**Flood Risk Management Policy**  
**Public Exhibition Submission**

**Flood Risk Management Policy**  
**Public Exhibition Submission**  
**03\_Submission 1\_Attachment 1**

# **SUBMISSION FORM - Flood Risk Management Policy Form Submission**

Source: Camden Council 2022 draft *Flood Risk Management Policy Appendix 1 Figure 3*  
*Extent of Camden Heritage Conservation Precinct for the purpose of Development Control Matrix*

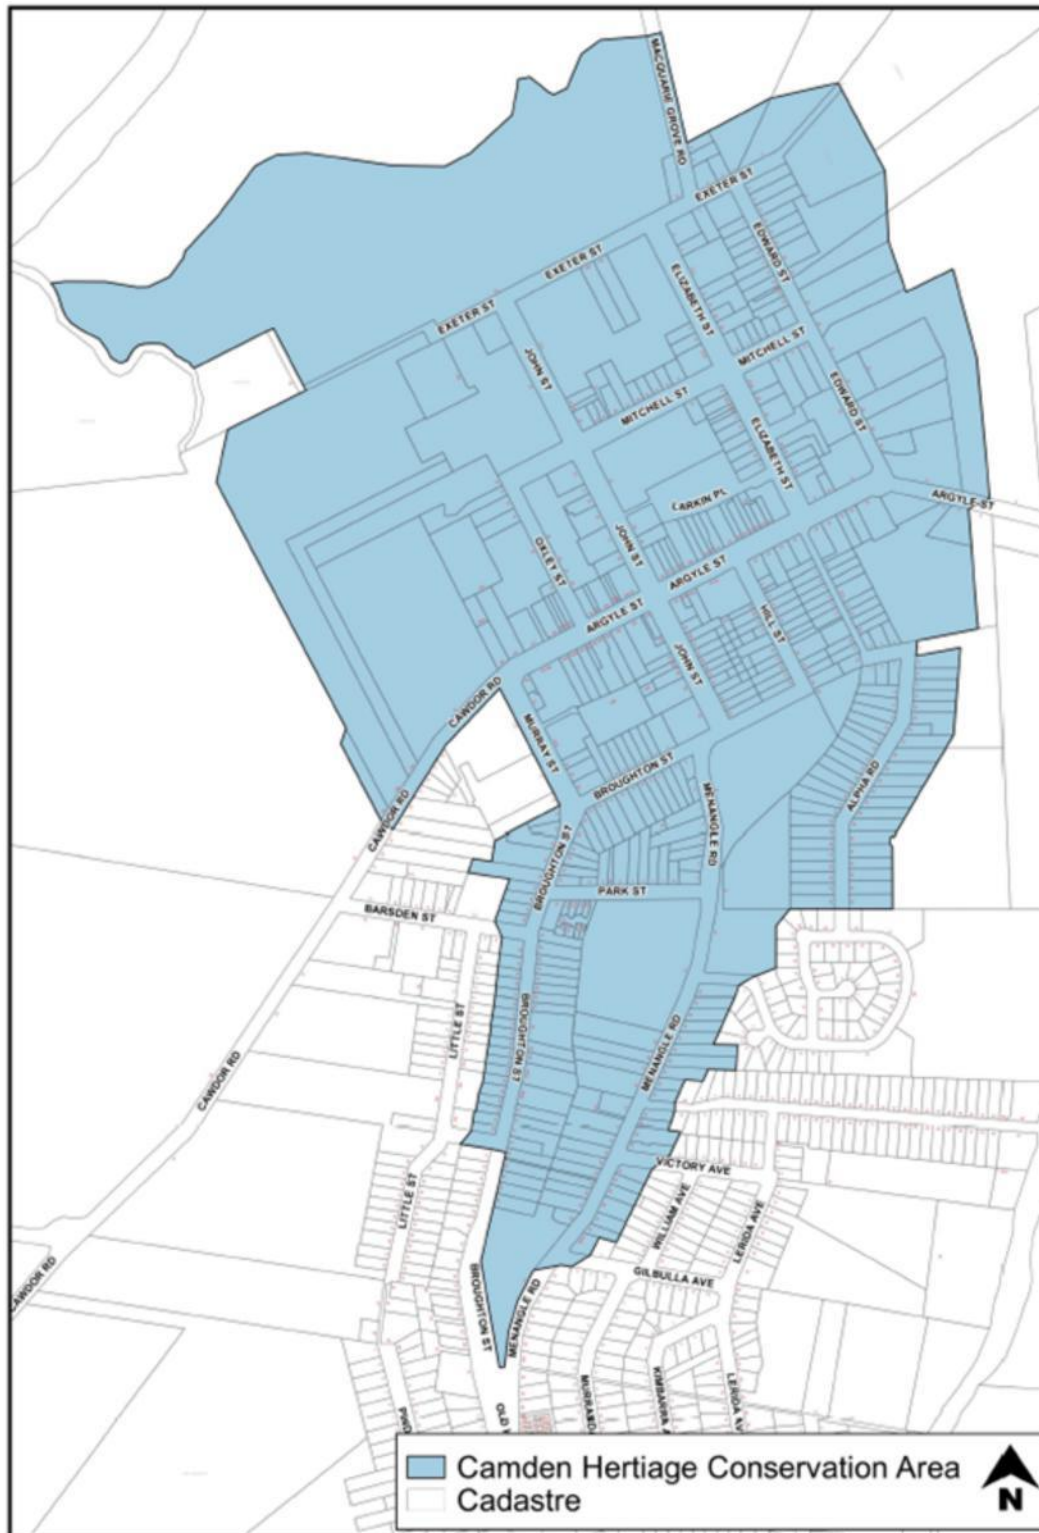
### **THE HCA CONCESSIONAL DEVELOPMENT CLAUSE MUST BE DELETED**

Despite having asked the question a number of times, we are at a complete loss as to why the following extraordinary clause concerning the Heritage Conservation Area (HCA), without any explanation, has been included in the draft Flood Risk Management Policy (draft Policy) (7.3.7, pp 10-11):

***Concessional development in the case of development within the Camden Heritage Conservation Precinct: All Commercial and Industrial, Low, Medium and High-Density Residential developments (as categorised in this policy) located only within the Camden Heritage Conservation Precinct shown in Figure 3 of the Appendix 1*** (copied in below).

The development matrices (pp 28-29) contained in Appendix 3 of the draft Policy show the categories of flood risk and the applicable development controls numbered 1 to 7 (pp 24-27). Concessional development is allowed in the flood areas, including high risk areas.
